# ADDENDUM NUMBER TWO

## Project #26-C-0012

Riverview Terrace Generator Installation  
Cottage Grove, Oregon

February 03, 2026

ONE-LINE DIAGRAM - DEMOLITION

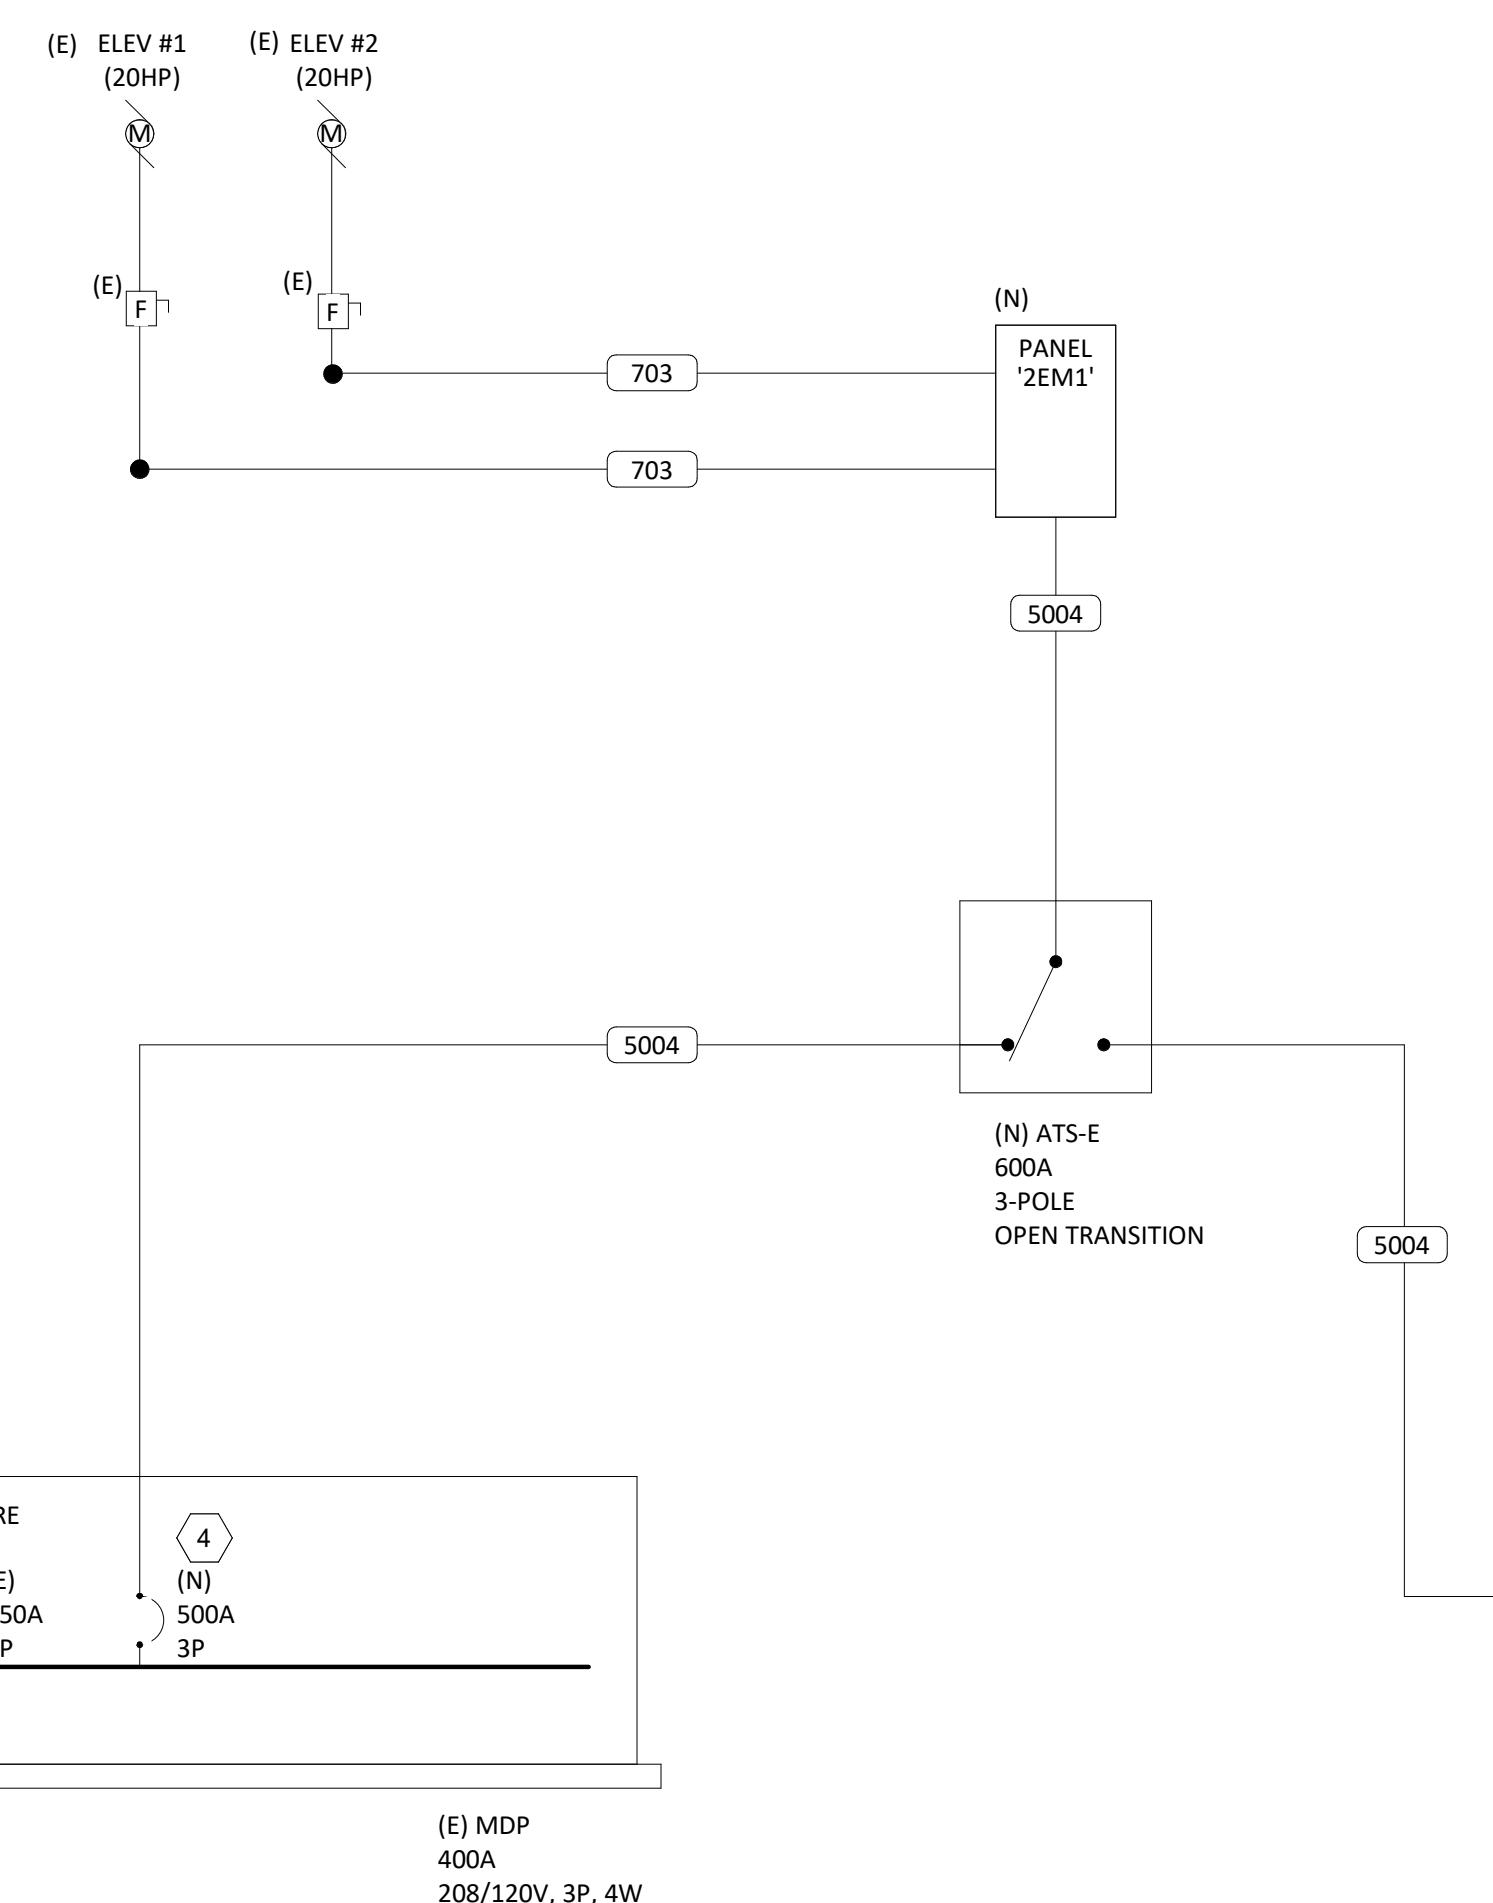
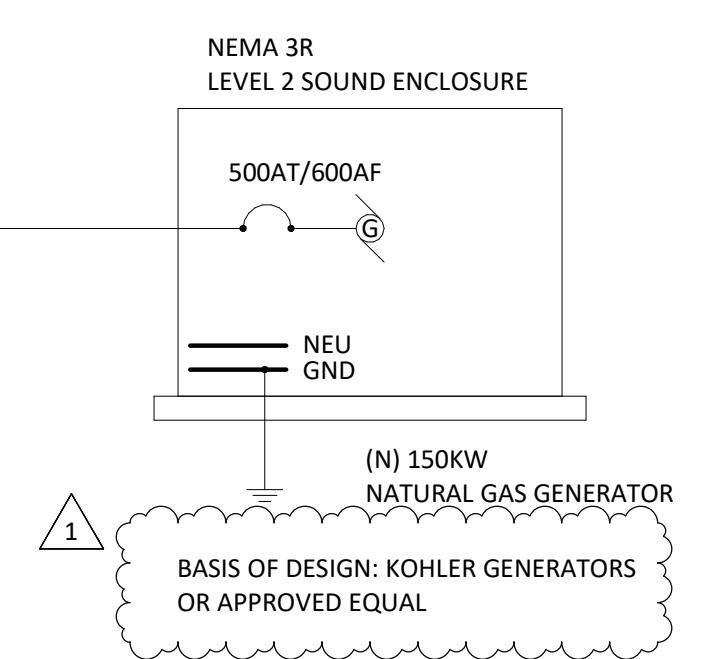
20250193 Riverview Terrace Generator Bid Questions		
#	Question	Response
1	NW Natural proposal be shared	See attached document.
2	Generator spec's (cut sheet of type – alternate manufacturers can be submitted for review)	Kohler is basis of design. Alternate manufacturers can be submitted for approval.
3	Waterproofing considerations due to grade & installation	There will be additional detailing for weather-proofing at the new conduit penetrations.
4	Any additional Architectural details to share/Site plan	There are no additional site plan details. If specific clarification is needed, additional information can be provided at the the time of request.
5	Will structural & architectural plans referenced on Sheet C100, Keynote 1 & E100, Keynote 1, be issued?	Reference STRUC sheet S1 - (ND, STRUC)
6	Will model(s)/manufacturer(s) be specified for the generator?	See updated drawings
7	Will model(s)/manufacturer(s) be specified for a "Level 2 Sound Enclosure" per 2/E002?	See updated drawings

13	Did you verify that a 500 A breaker will fit in the existing bussing when we take out the two 150A breakers for the elevators.	Based on visual inspections, we believe the breaker will fit but it is the responsibility of the contractor to verify.
